XI. LETTERS RECEIVED DURING THE DRAFT ENVIRONMENTAL ASSESSMENT REVIEW PERIOD AND RESPONSES TO SUBSTANTIVE COMMENTS

A Draft Environmental Assessment for the subject project was filed and published in the Office of the Environmental Quality Control's The Environmental Notice on March 23, 2008.

This letter responds to your March 17, 2008 request for comments regarding the Draft Environment Assessment (EA) to the proposed Kula Ridge Residential Workforce Housing Subdivision. The project site is located within TMK (2)2-3-001:174, at Latitude 20.763° N. and Longitude 156.323° W., in Kula, Island of Maui, Hawaii. It has been assigned number POH-2006-304, which should be referred to in all correspondence with us.

DISTRIBUTION OF SITE-GENERATED TRAFFIC
ALTERNATE SCENARIO

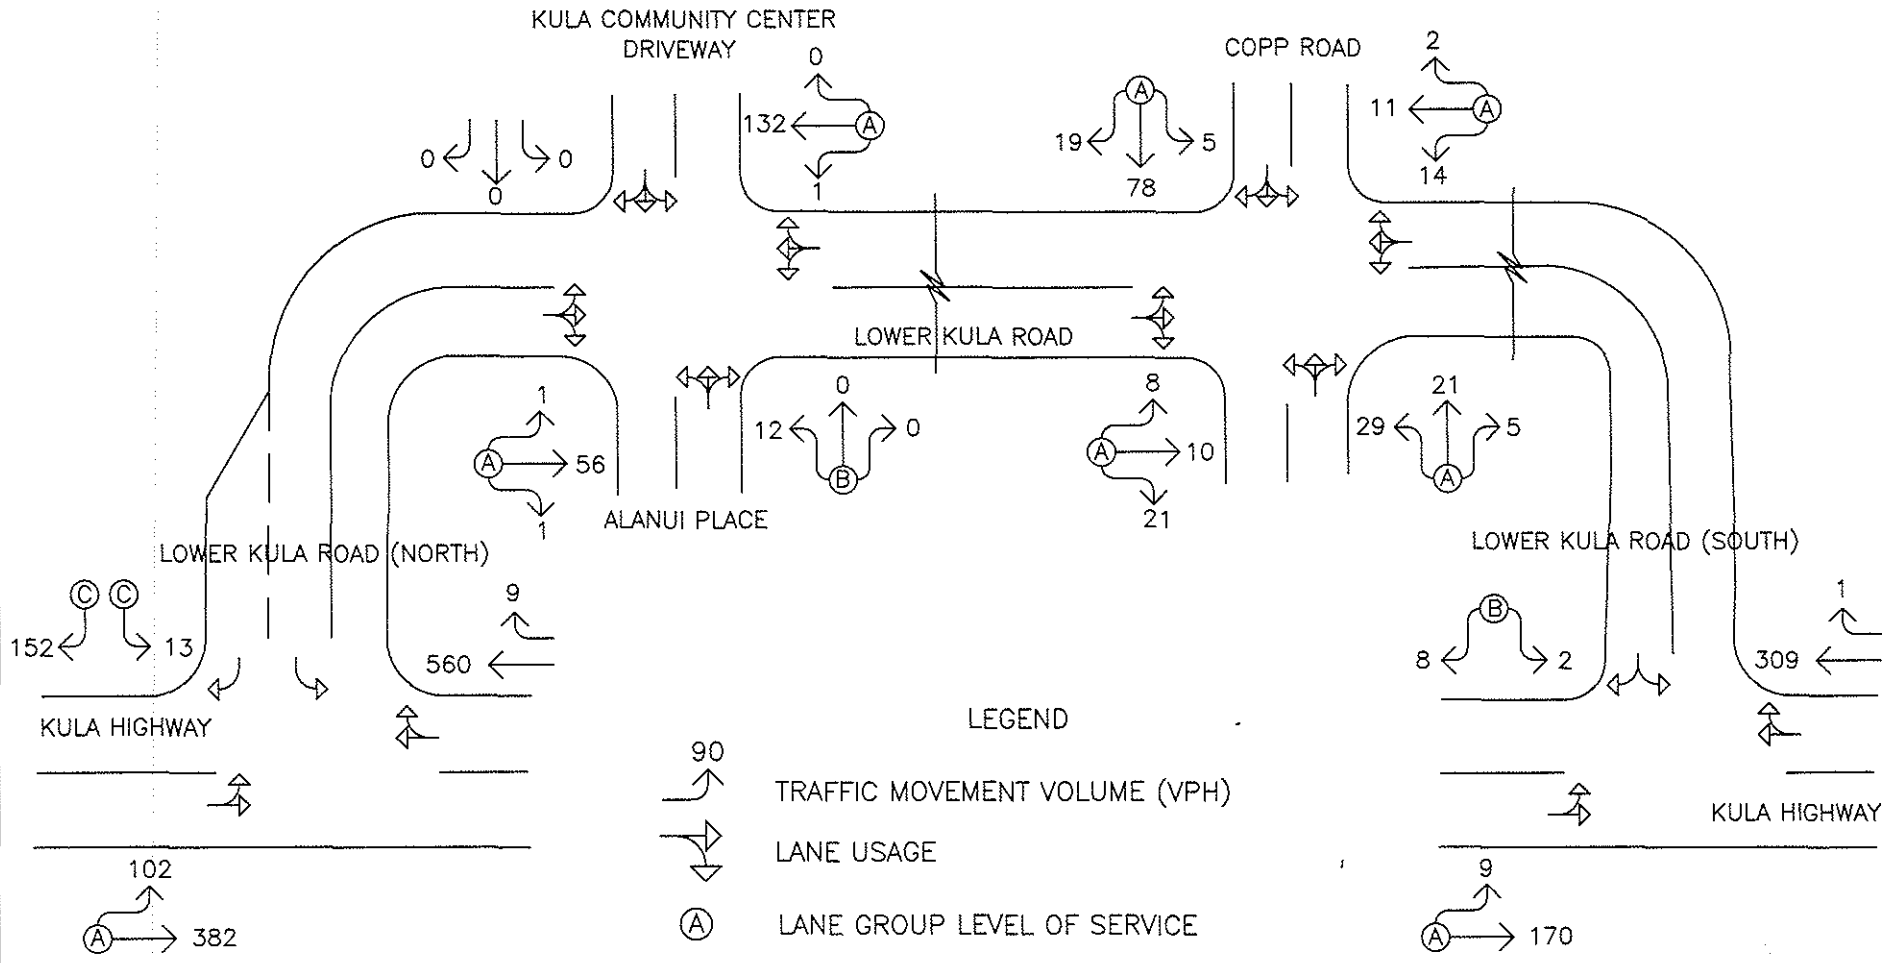
- c. The assumed distribution of project-generated traffic presented in the TIAR that traffic from an affordable/workforce housing project would flow onto Copp Road and travel to/from another residential area is questionable. As an affordable housing project, this development could be viewed as an aid in fulfilling the

As requested, we assessed an alternate trip distribution scenario for the Kula Ridge project to address comments provided by DOT. The following is a summary of our findings.
